Northeast National Petroleum Reserve-Alaska

FINAL Supplemental
Integrated Activity Plan/Environmental Impact Statement

Volume 4: Chapters 5 and 6

CHAPTER VI: COMMENTS AND RESPONSES

Figure 1: North Slope Oil and Gas Leases

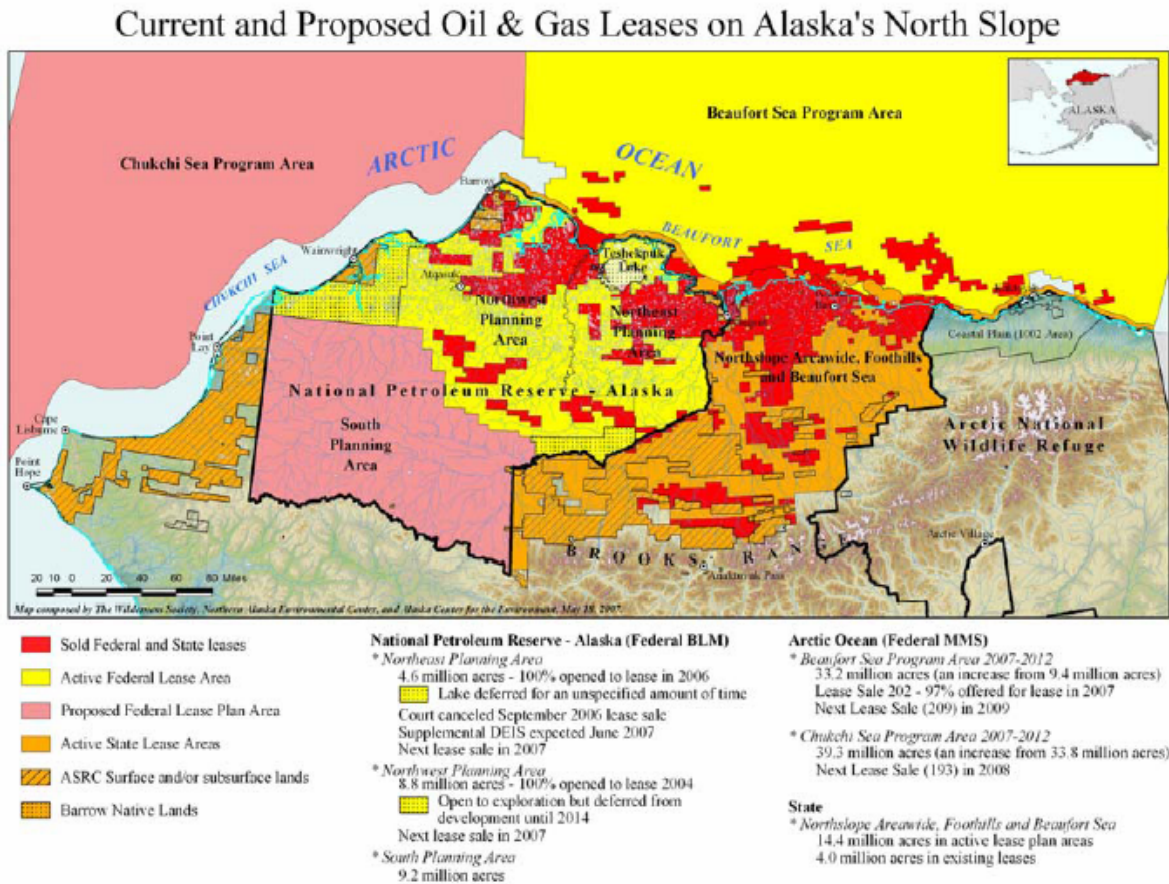
Additionally, the other significant source of cumulative effects on the resources of the NPR-A is further oil and gas leasing and development activity, both in the immediate vicinity of the NPR-A, and elsewhere in the range of the species dependant on the NPR-A. As the map below (Figure 1) demonstrates, the majority of the North Slope has either already been leased or is subject to a pending proposal for leasing. The species of the NPR-A such as the polar bear and yellow-billed loon face the very real risk of having most of their currently suitable habitat rendered unsuitable within the very near (and clearly foreseeable) future.

Figure 2: Offshore Oil Leases

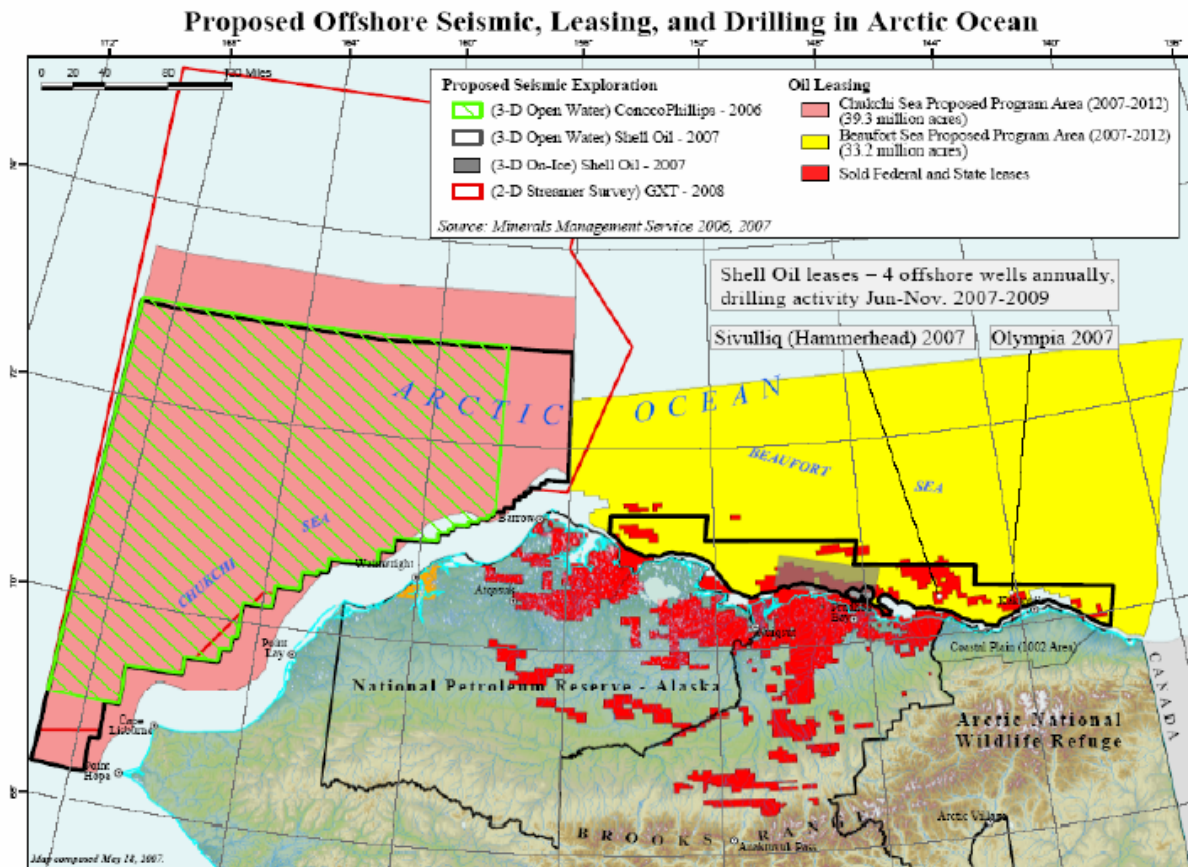
[25.019] While disturbance and development of the terrestrial habitat of the North Slope is of the greatest concern for species dependant on the region, we believe BLM must also examine the significant threat posed to the species by offshore oil and gas development. On June 29, 2007 Secretary of Interior Kempthorne approved the 2007-2012 Program for leasing of the Outer Continental Shelf. In the Program, lease sales are planned in the Chukchi Sea in 2008, 2010, and 2012, in the Beaufort Sea in 2009 and 2011, and in Cook Inlet in 2009 and 2011 and the Bering Sea in 2011. These areas are all either foraging habitat or wintering habitat for the eiders and loons that nest in the NPR-A. In addition to planned lease sales, activity on existing offshore leases is scheduled or now underway, including exploration drilling by Shell and BP's planned development of the Liberty prospect. Because yellow-billed loons and eiders forage offshore of their breeding areas, as well as in their wintering areas, they are highly vulnerable to direct impacts from offshore development. Additionally, construction and operation of offshore facilities will result in increased helicopter activity over onshore breeding areas along with other land-based disturbances related to servicing offshore operations. These offshore activities will affect not only waterbirds, but also polar bears and other marine mammals. See Figure 2 below.

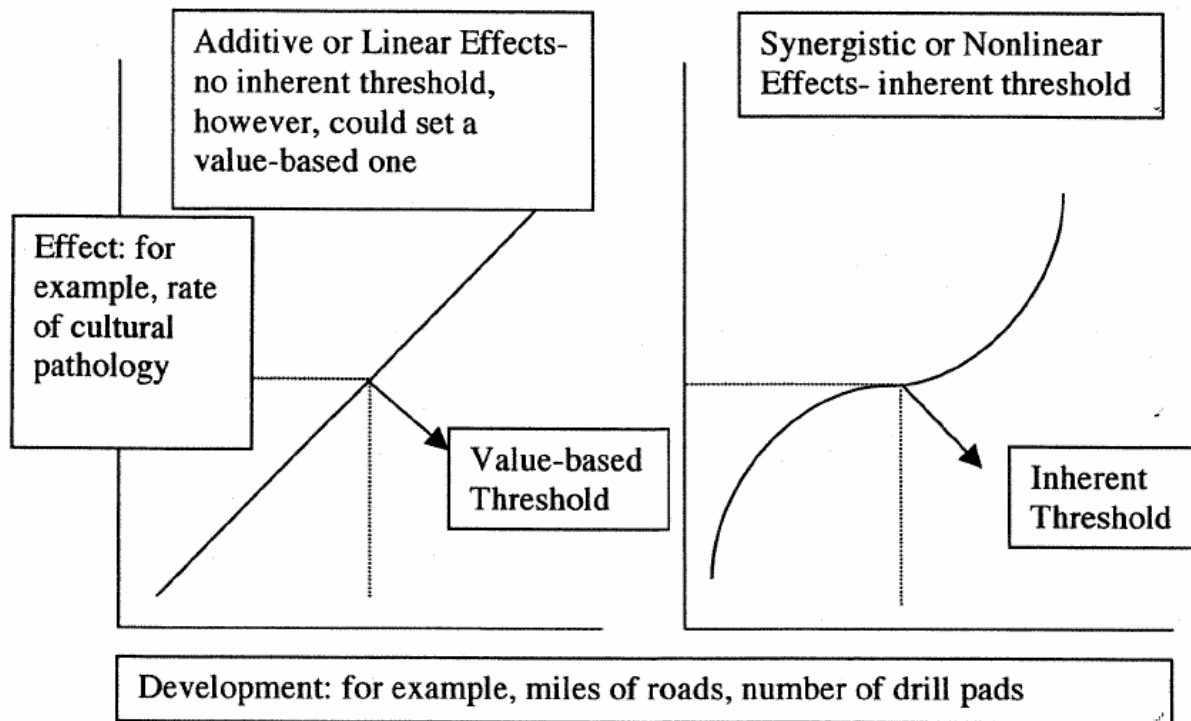
While the Draft Supplemental EIS discusses in great detail the specific past and possible future effects of oil and gas development on the North Slope, they fail to combine expected impacts in any systematic or coherent manner.

[76.004] The emergent properties of combining specific effects could be identified by taking the existing 300 pages of specific cumulative impacts and combining them in a simulation model. Not only would this model be a more accessible and instructive way of presenting the cumulative effects analysis, but it would also show how the myriad of effects may interact with each other. By being able to adjust the intensity and spatial arrangement of development and other variables, the public and decision-makers will quickly gain a greater understanding of what the combined cumulative impacts may be of different development scenarios.
